Staff Report for PLSUP-2603-0005

Application Type: Special Use Permit
Location of Subject: 8325 Knowlton Blvd
Legal Description: 010-2744-00105

Applicant is requesting a Special Use Permit to upgrade electrical components related to the water pump station on the site.

SITE LAYOUT PLAN
STATION 2

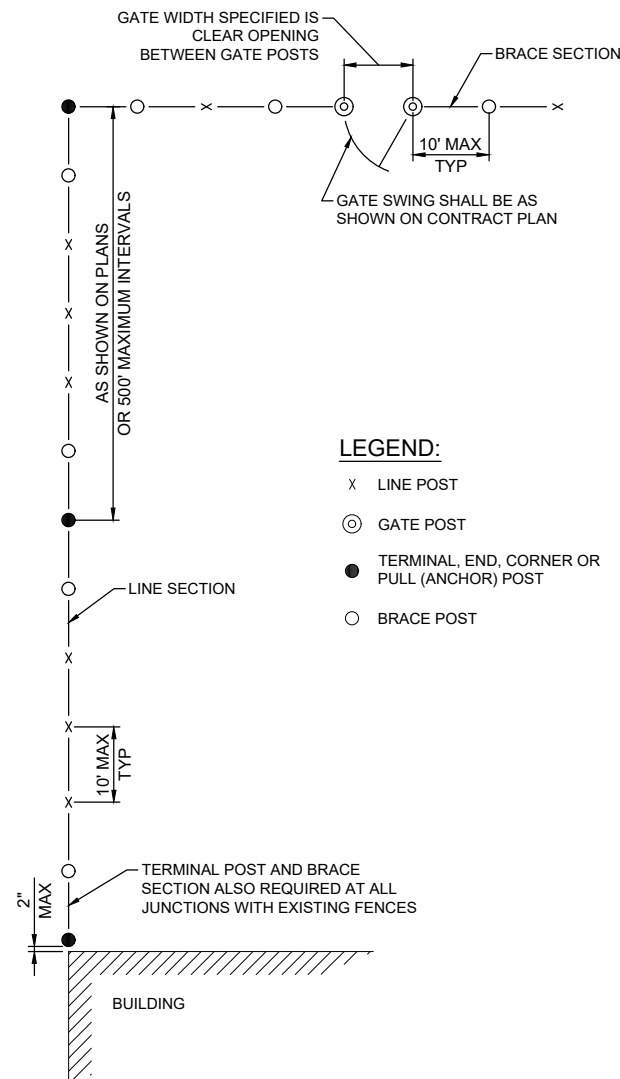
3. *Shoreland Overlay (50-18.1.D)*: The site is within a cold-water shoreland zone of a tributary of Knowlton Creek. A portion of the project is within the 150' structure setback. A companion application, PLVAR-2603-0007, has been submitted to allow for encroachment into this setback. To offset impacts, the applicant proposes establishing a no-mow area to improve the vegetated buffer adjacent to the tributary.

CONSTRUCTION DETAILS STATION 2

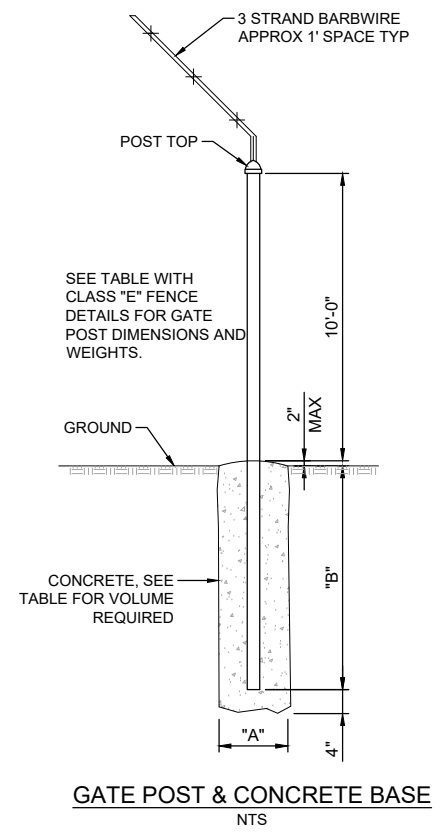
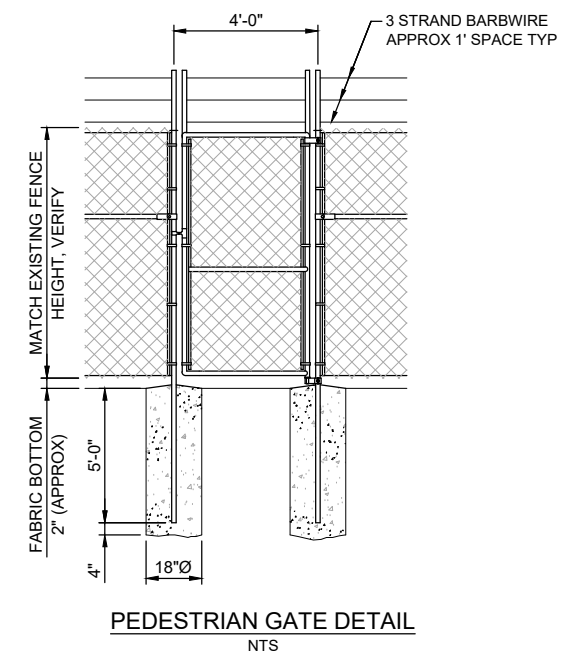
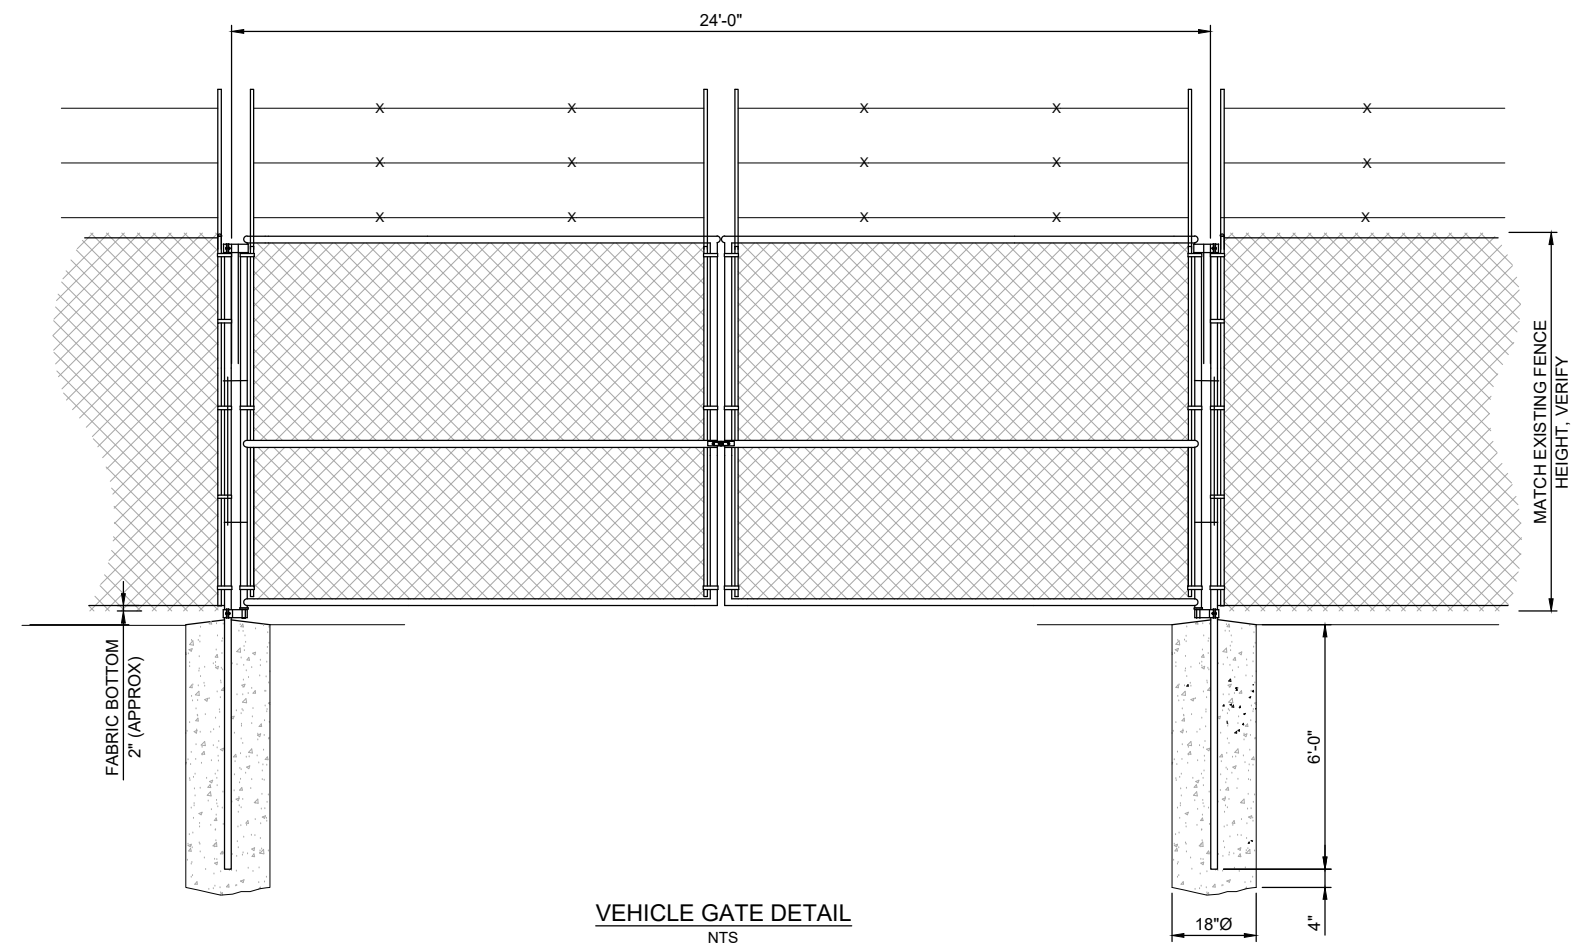
4. *Screening (50-26.1)*: The electrical components will be screened by vegetation depicted in the landscaping plan.
5. *Fencing (50-26.4)*: This fence serves a bonafide public safety purpose and is exempt from the prohibition on the use of barbed or razor wire. The proposed fencing is within a rear yard area where maximum fence heights are 8 feet. The fence height is determined by the cumulative heights of the fencing material and barbed or razor wire.

1. The project must be constructed and limited to the plans submitted with the application.
2. The proposed fencing may not exceed a height of 8'.
3. Approval of this permit is conditional to approval of PLVAR-2603-0007.
4. An updated landscaping plan must be approved by the Land Use Supervisor prior to building permit approval that

**LANDSCAPE PLAN
STATION 2**

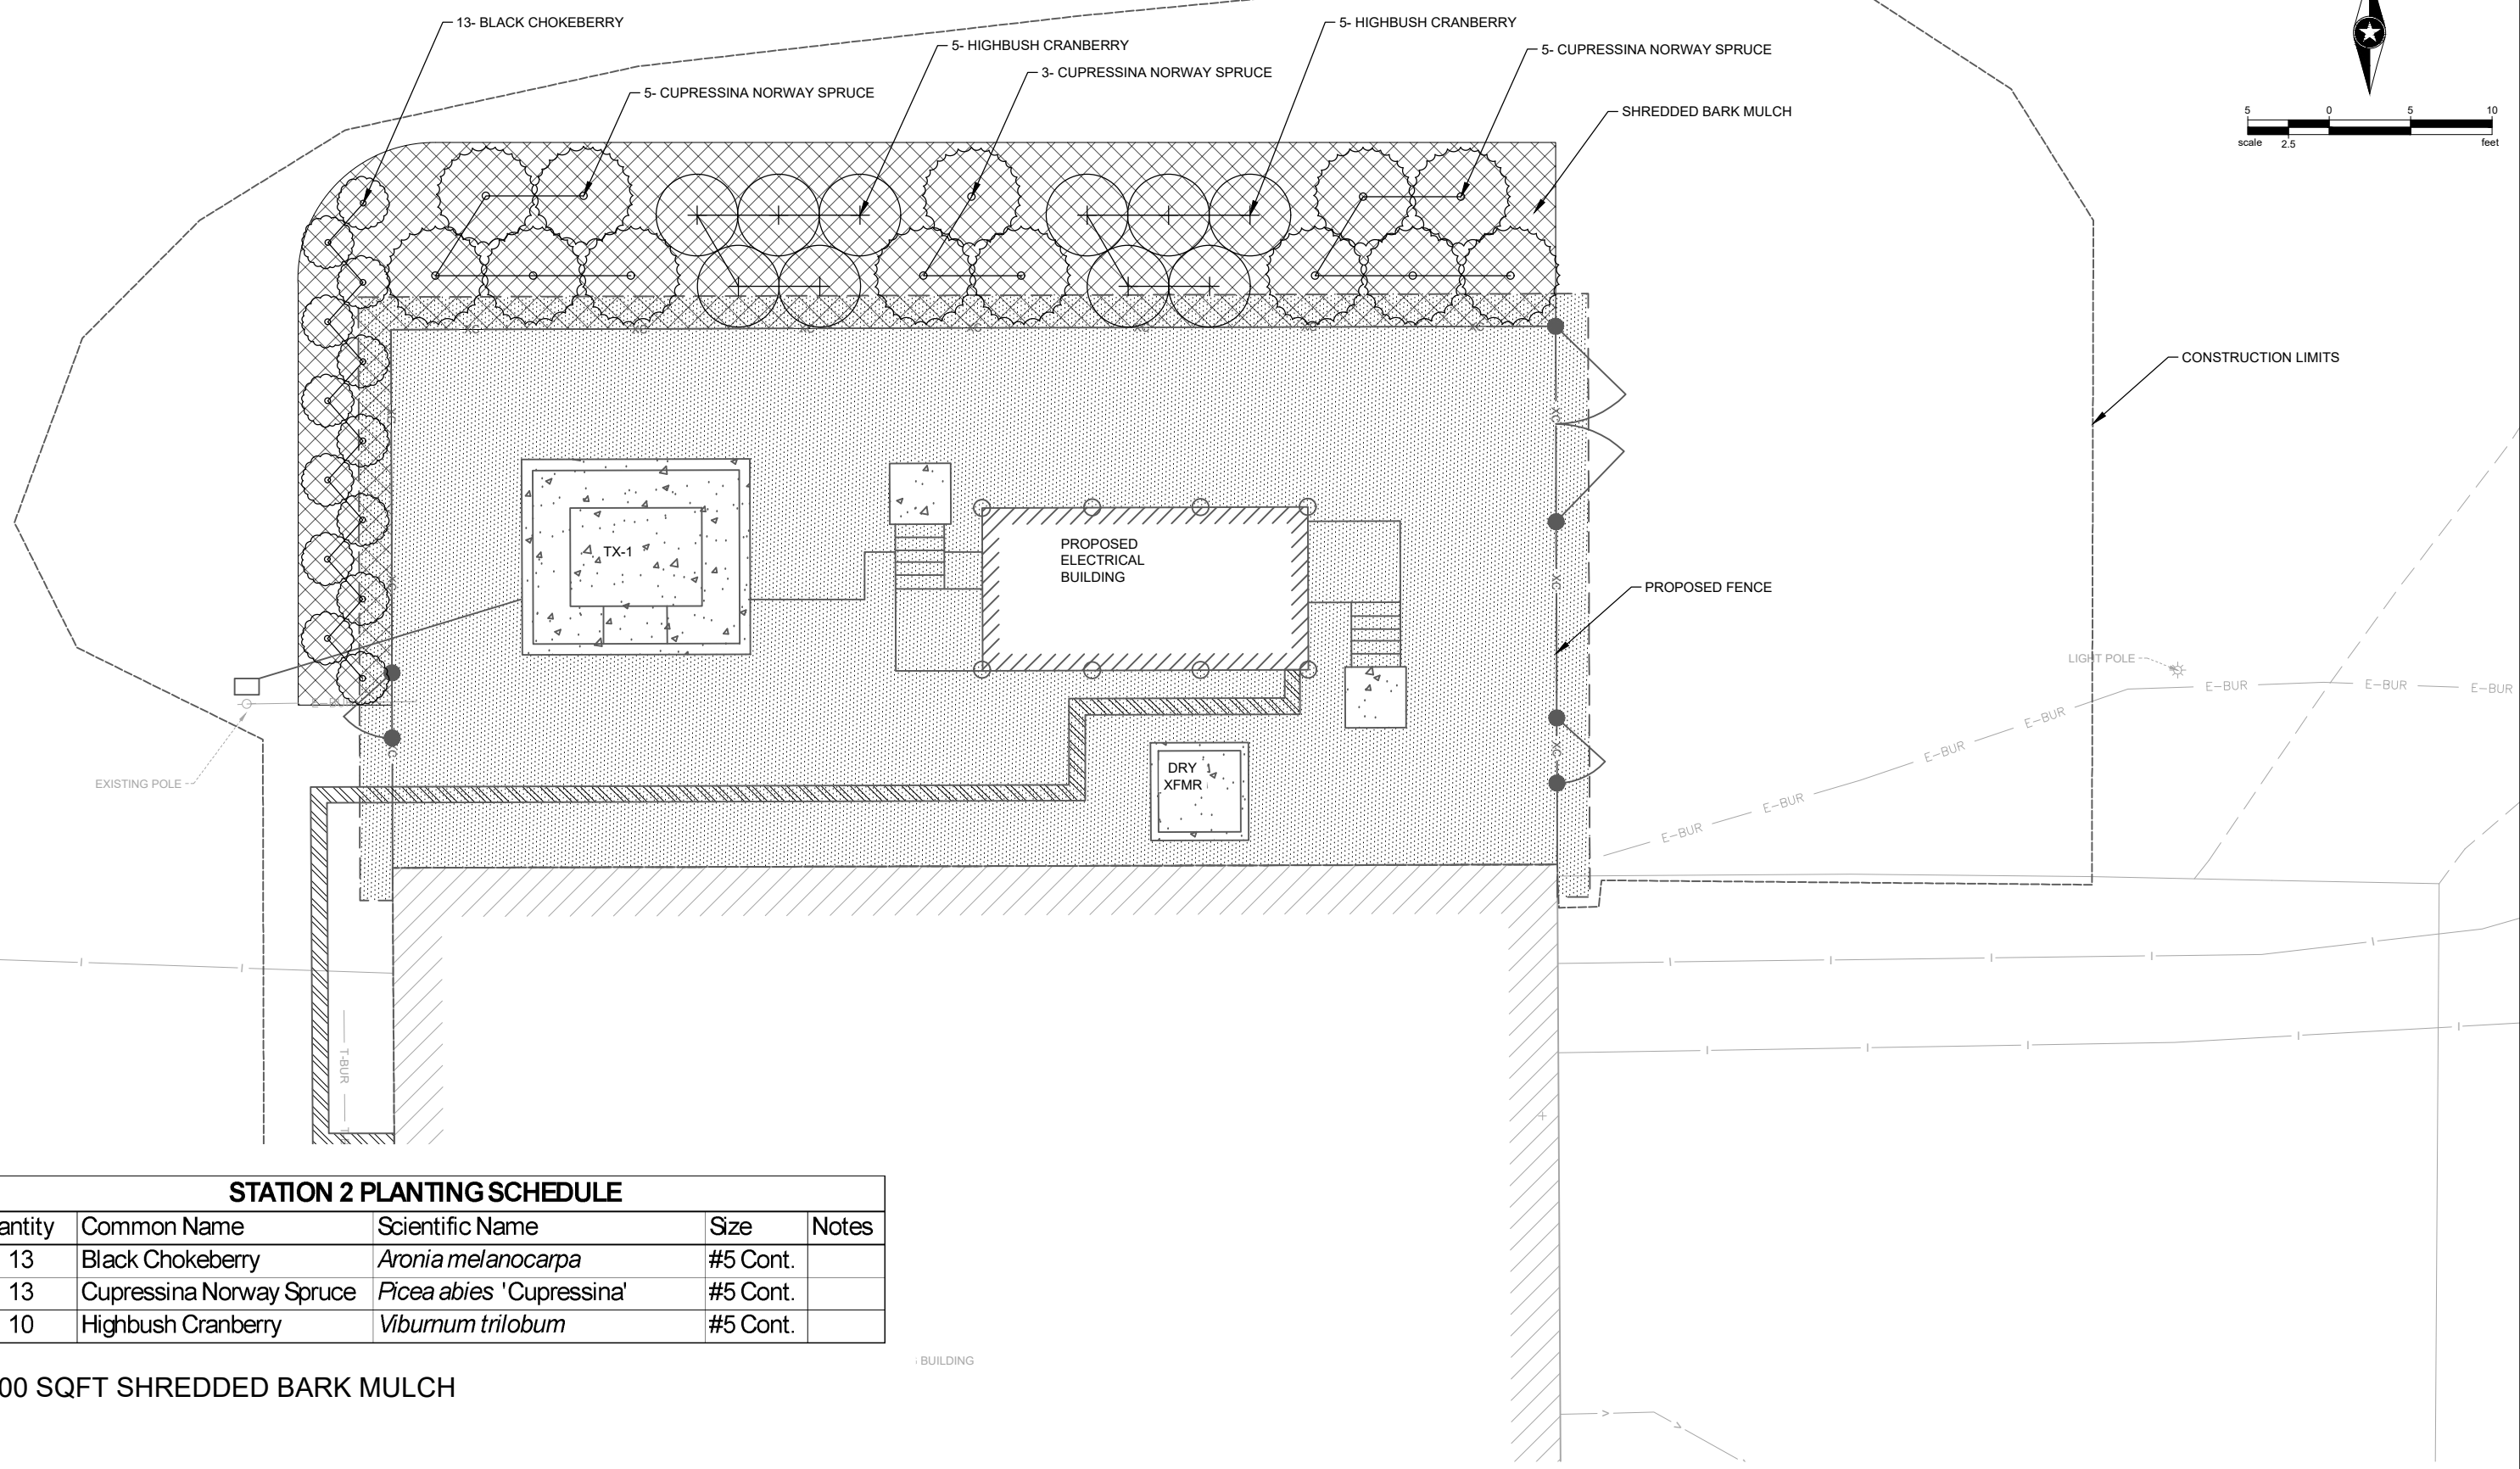
7. City of Duluth Parks staff recommended that the spruce trees be replaced with a native evergreen tree to avoid unwanted reproduction of the spruce in the surrounding forest.

replaces the spruce trees with a native evergreen.
